Dogger Bank South Offshore  
Wind Farms

Project Change Request 2 – Onshore Substation  
Zone

Document Reference: 10.53

Revision Number: 01

Figure: 2b      Drawing No: PC2340\_LUC\_ON\_ZZ\_DR\_Z\_2b

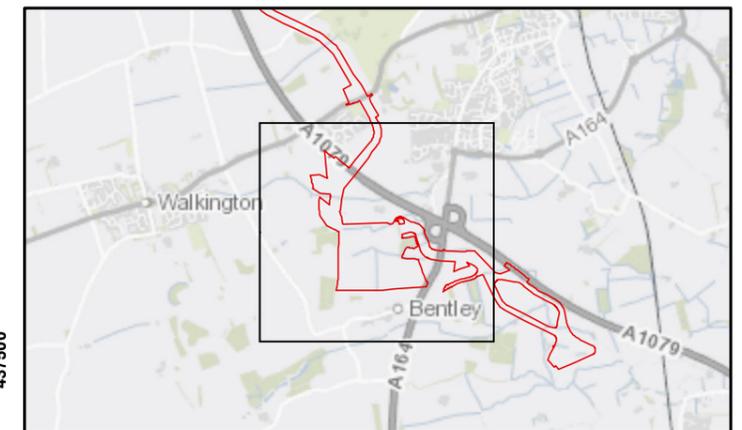
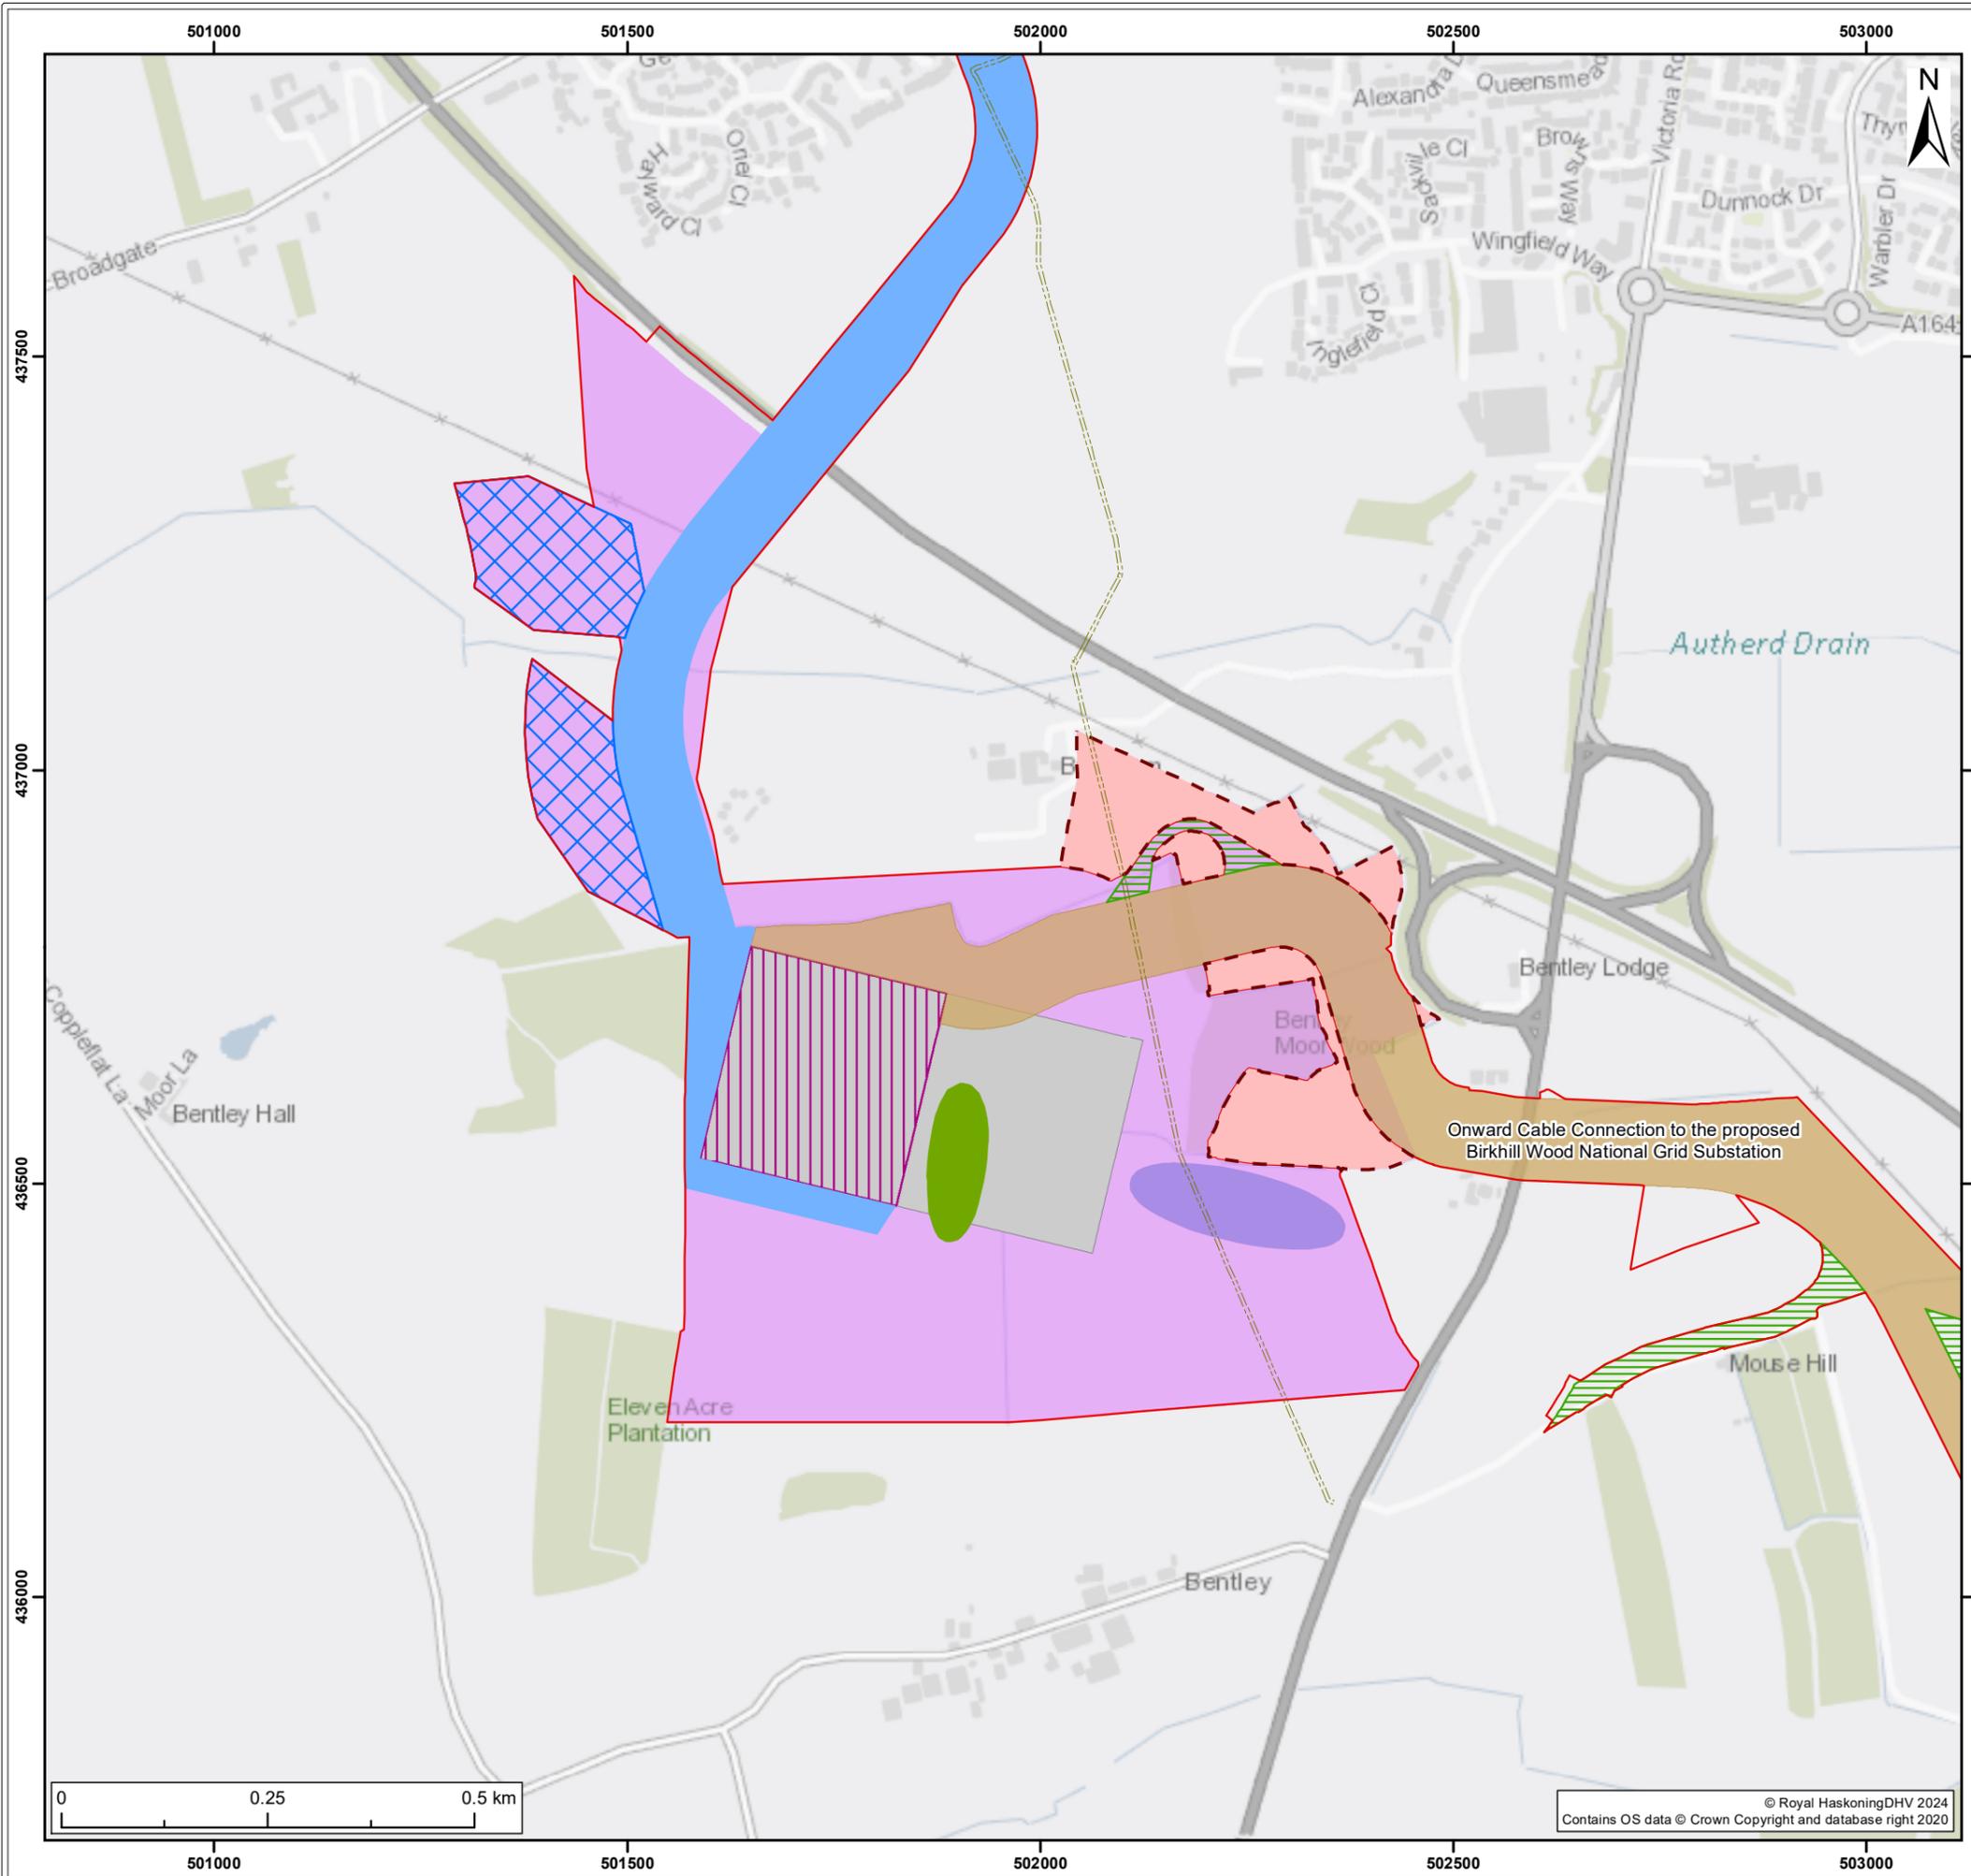
- Minor updates to the Indicative Landscape Plan at the Onshore Substation Zone as presented on Figures 2(a) and 2(b) (Appendix A);
  - Reduction in size and change of indicative location of Sustainable Drainage System (SuDs) requirements as presented on Figures 1(a) and 1(b) (Appendix A);

101. The smaller footprint of the Onshore Converter Station(s) provides more flexibility in developing the proposed landscaping around the Onshore Converter Station(s). An updated Indicative Landscape Plan (Figure 2b) was produced to reflect the reduced Onshore Converter Station(s) footprint. Changes in the updated plan include providing a more continuous belt of woodland along the eastern boundary, enhancement of existing watercourse vegetation within the Site, and additional woodland planting to the east of the Onshore Converter Station(s) which would provide a layering effect in views from the south-east. Woodland planting along the eastern extents of the southern and northern boundaries has been reduced slightly given there would no longer be a Onshore Converter Station located further east within the Site. As a result, **no new or different** Landscape and Visual related likely significant effects are anticipated as a result of the proposed change.
